CONSTRUCTION DOCUMENTS FOR:
HAVEN VALLEY
 (LETA DR.) BRADLEY RD/ALTURAS DR.
 SECURITY, EL PASO COUNTY, COLORADO

v1_Construction Drawings.pdf Markup Summary 10-19-2023

EAST FOREBAY
1"=5'

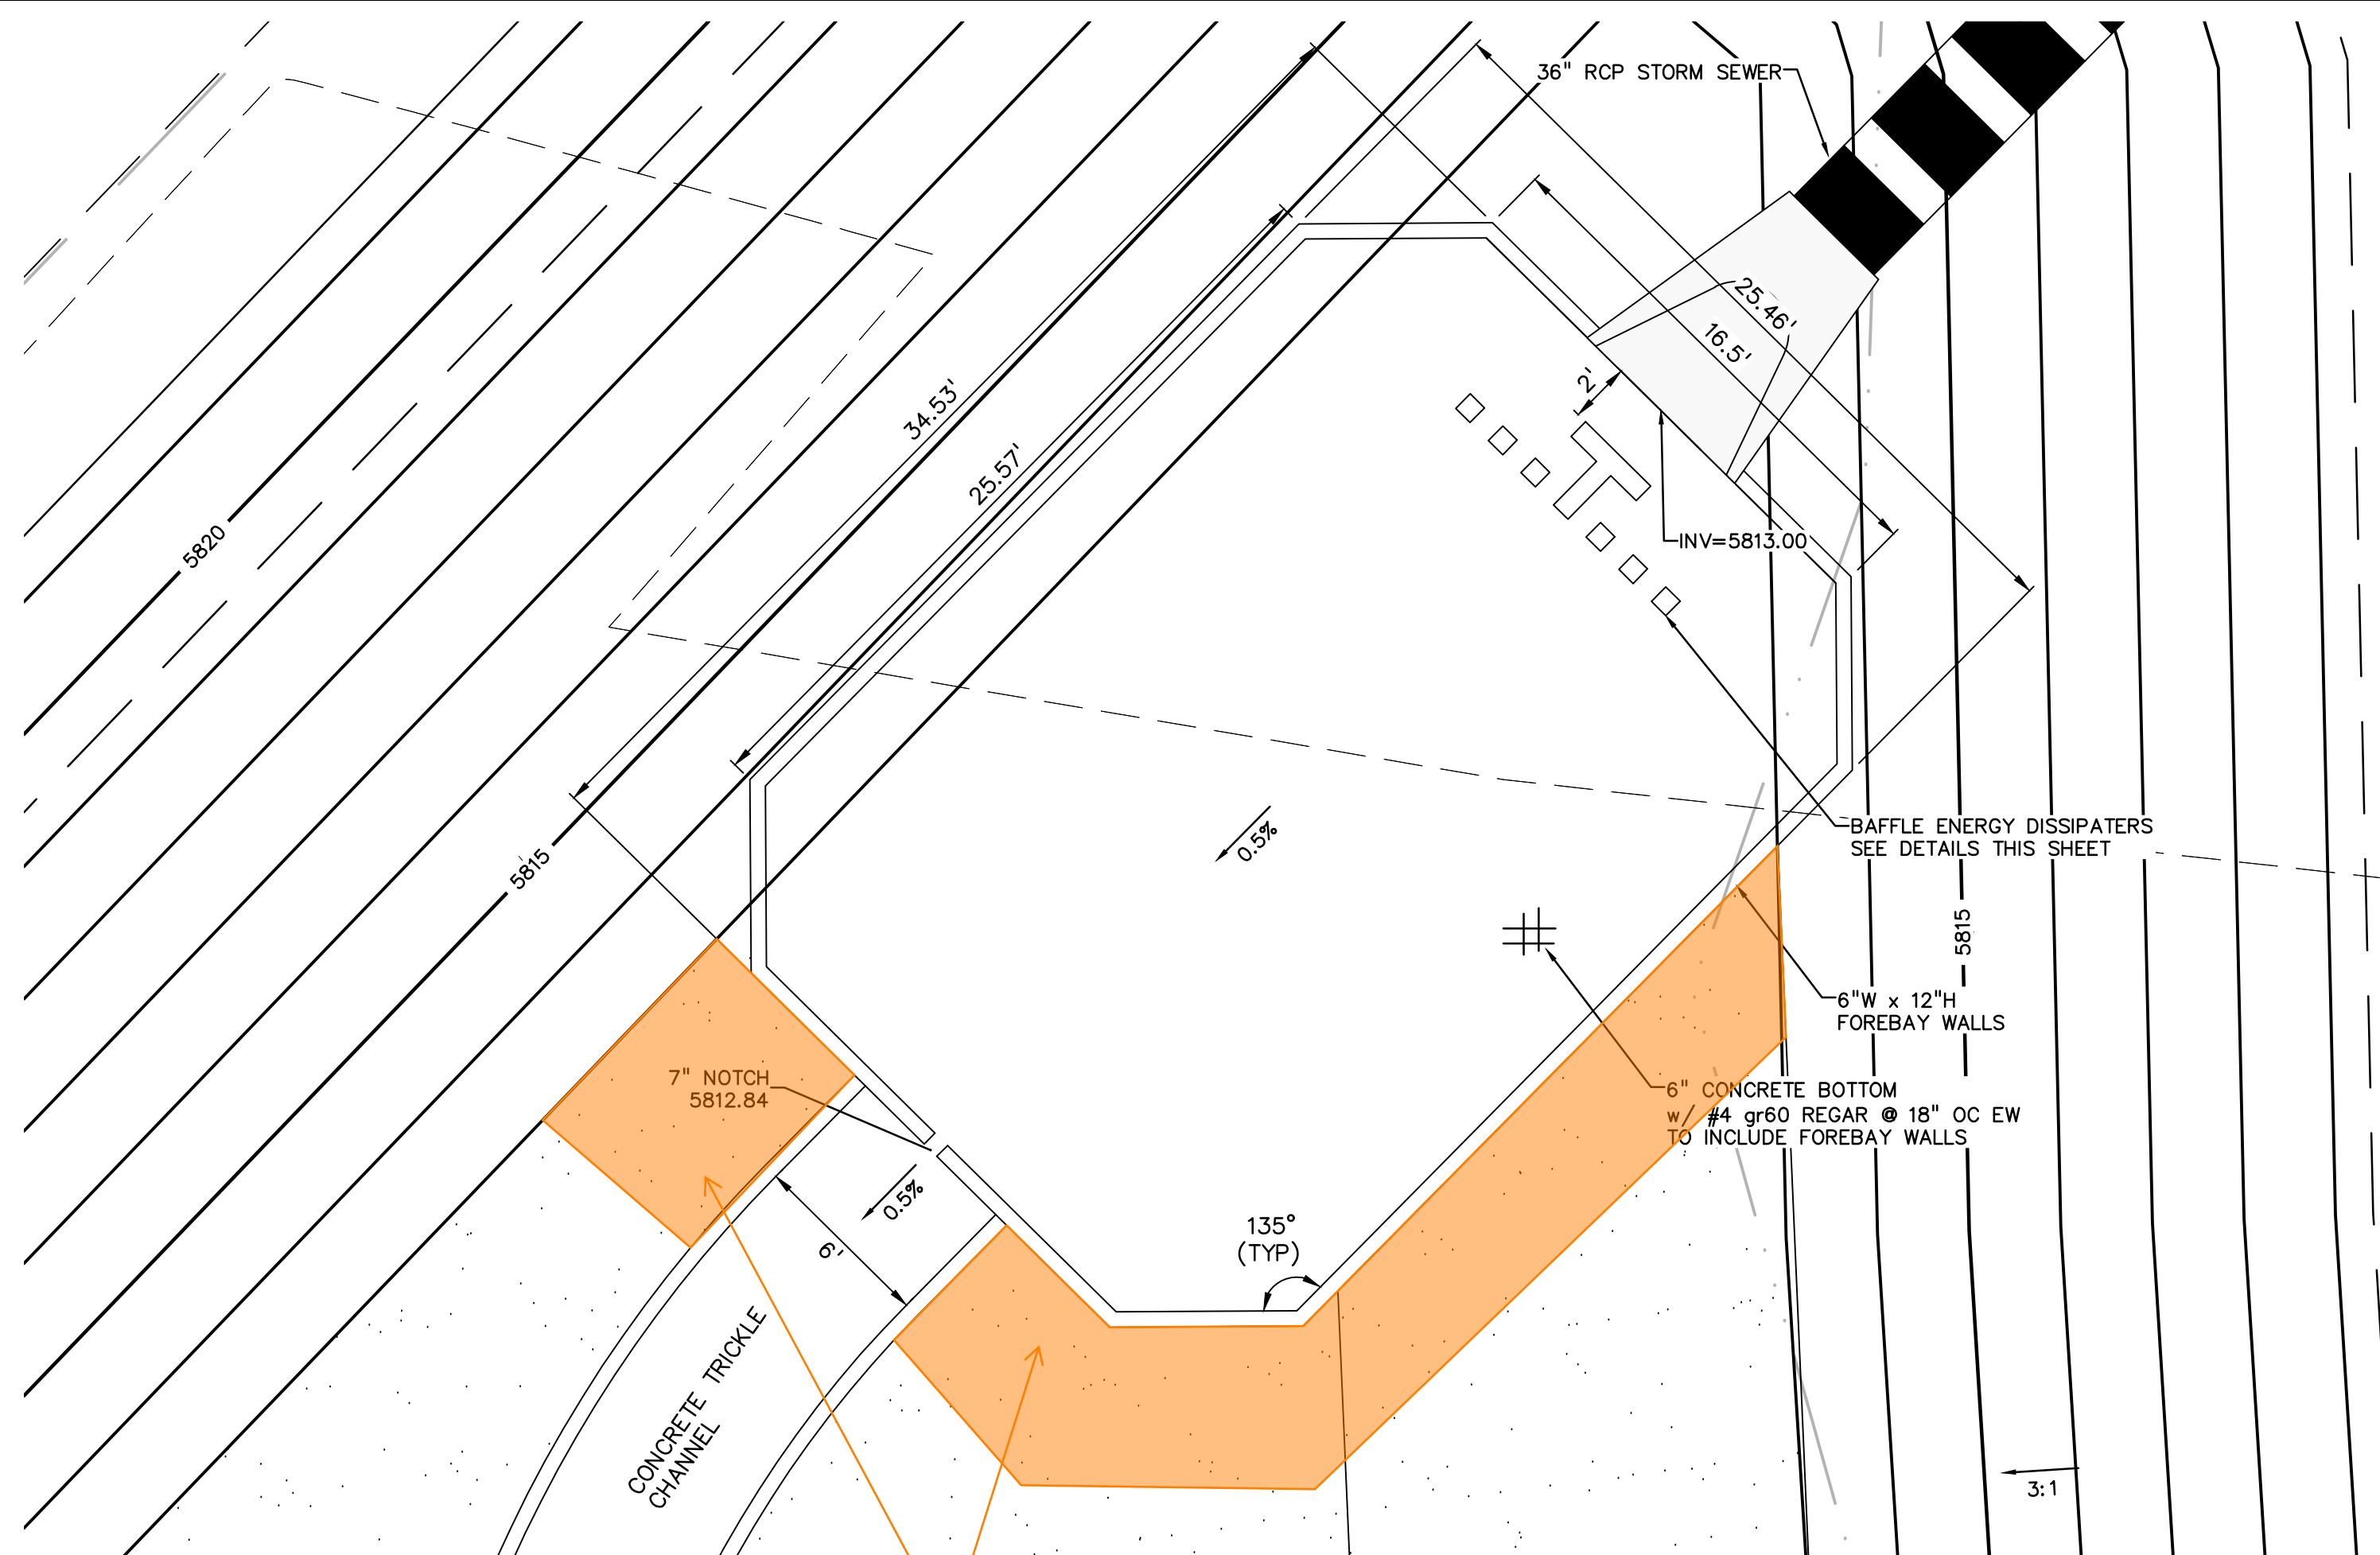
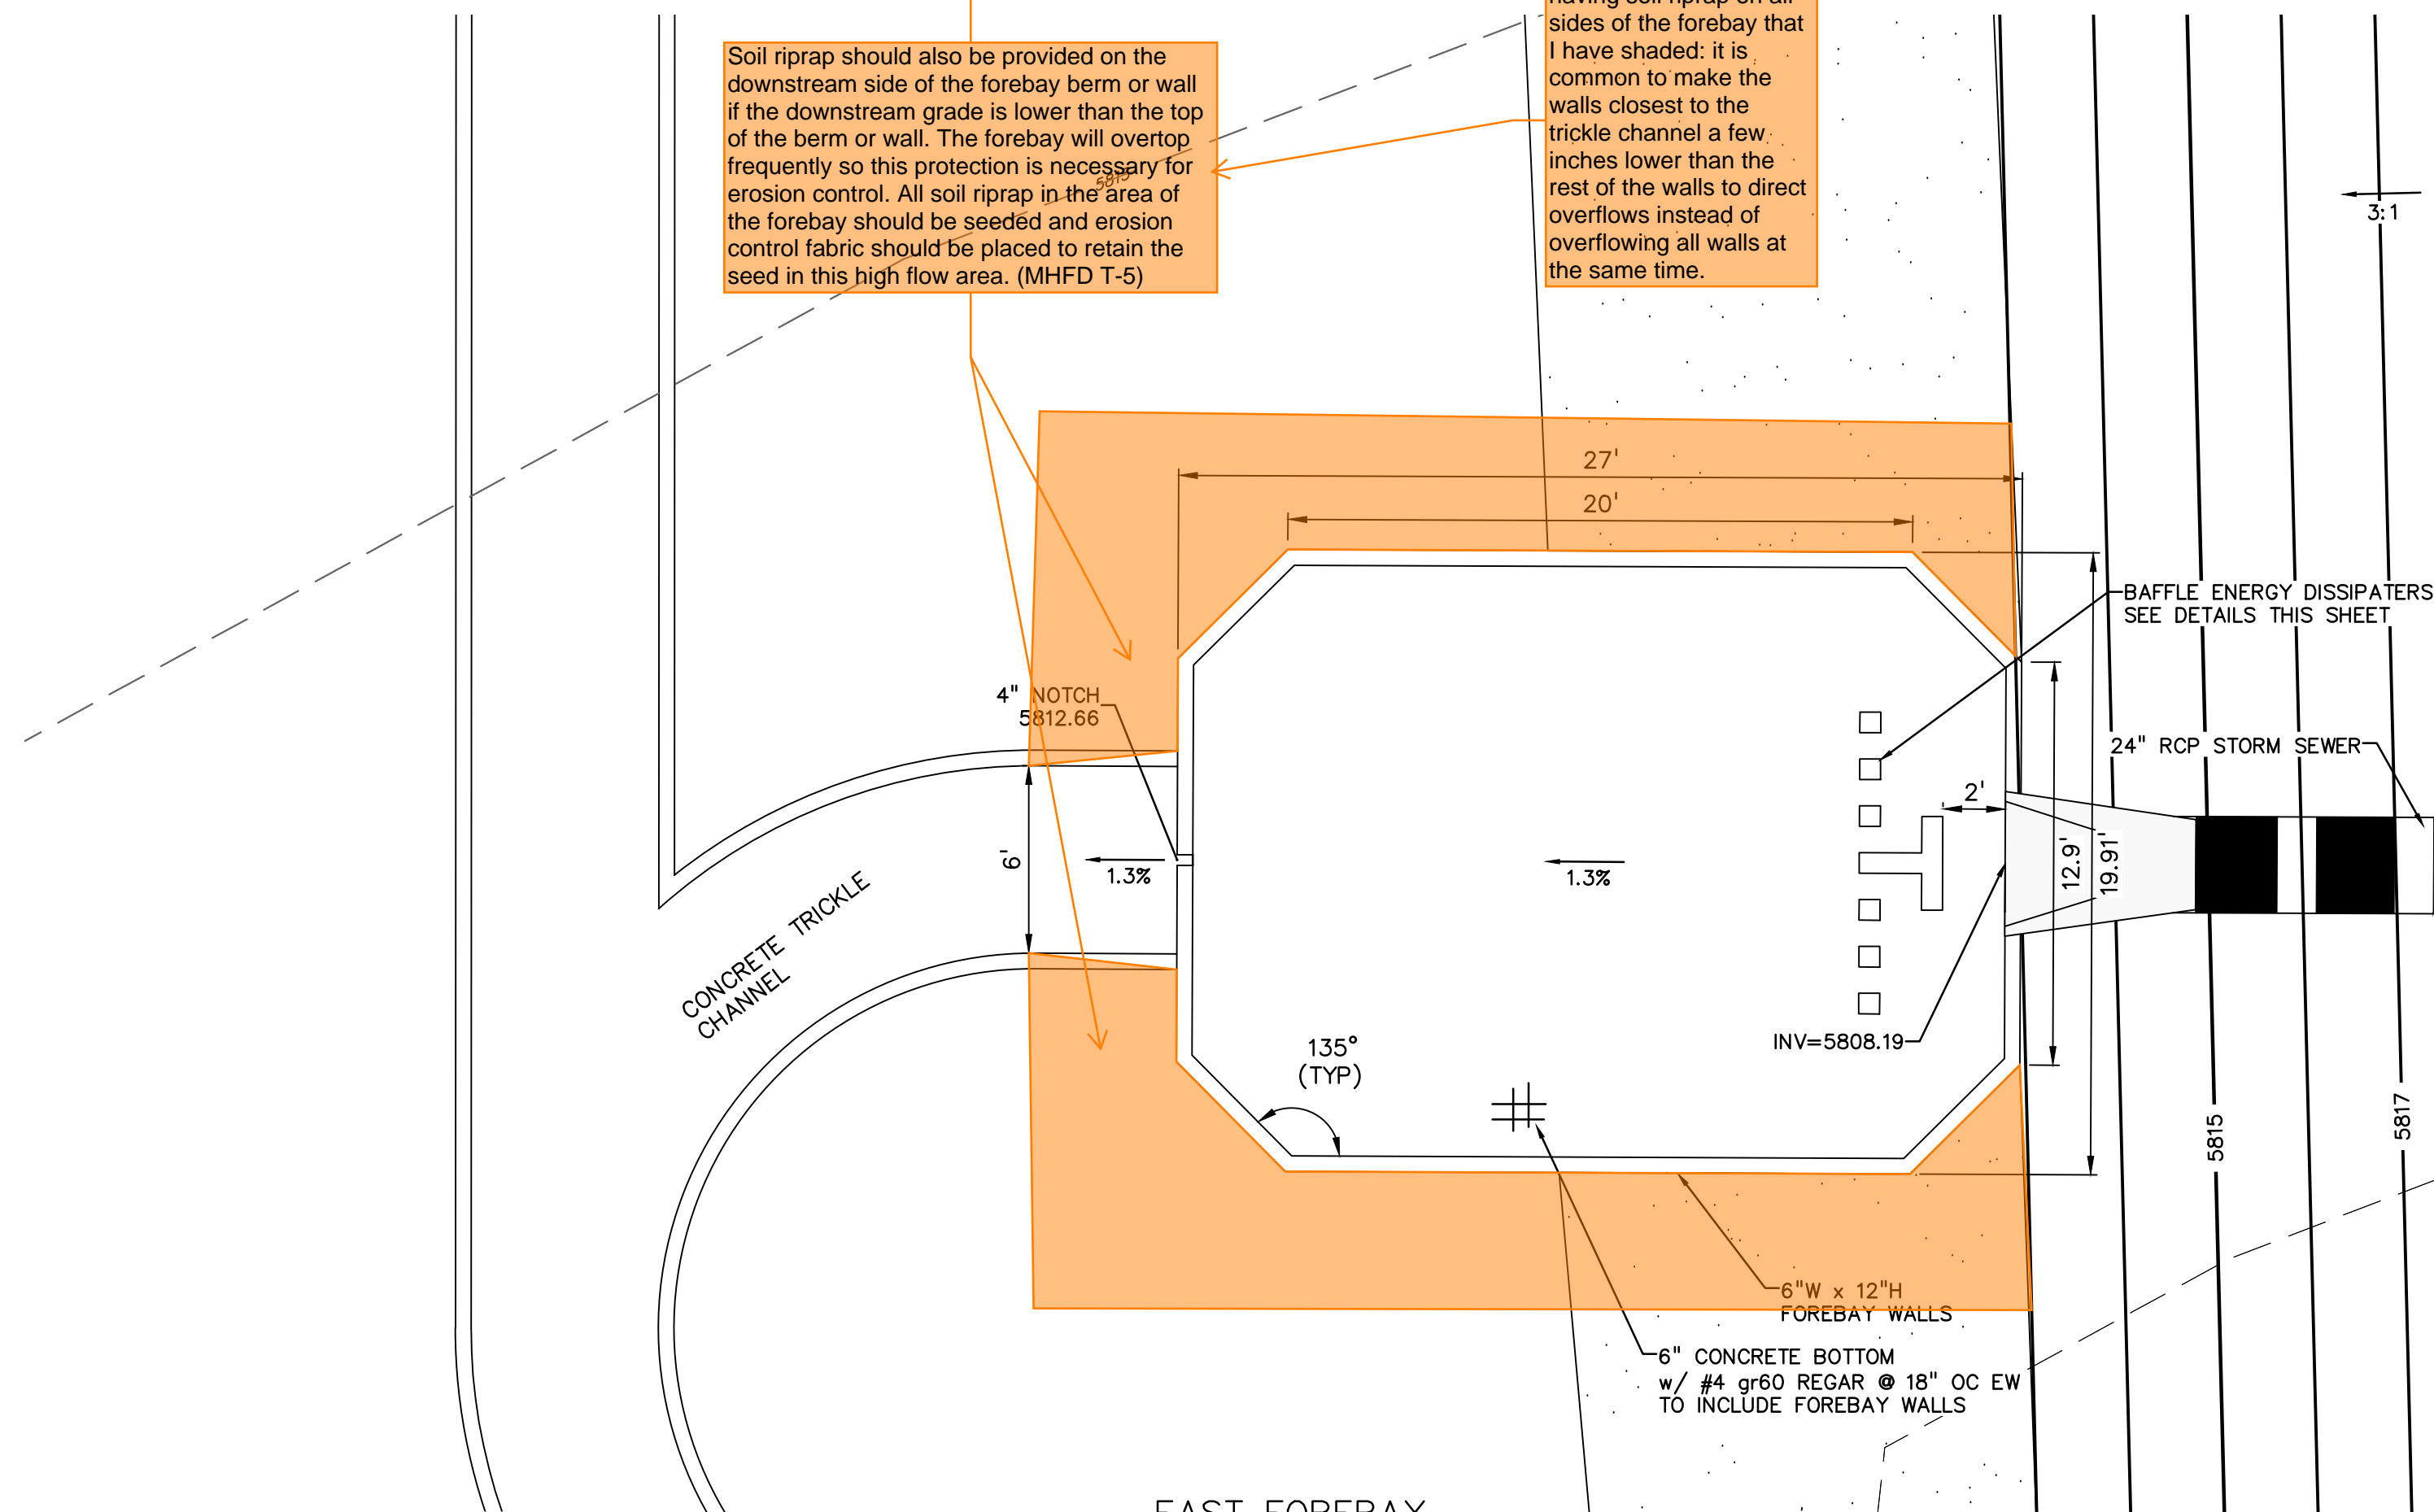
Soil riprap should also be provided on the downstream side of the forebay berm or wall if the downstream grade is lower than the top of the berm or wall. The forebay will overtop frequently so this protection is necessary for erosion control. All soil riprap in the area of the forebay should be seeded and erosion control fabric should be placed to retain the seed in this high flow area. (MHFD T-5)

As an alternative to having soil riprap on all sides of the forebay that I have shaded; it is common to make the walls closest to the trickle channel a few inches lower than the rest of the walls to direct overflows instead of overflowing all walls at the same time.
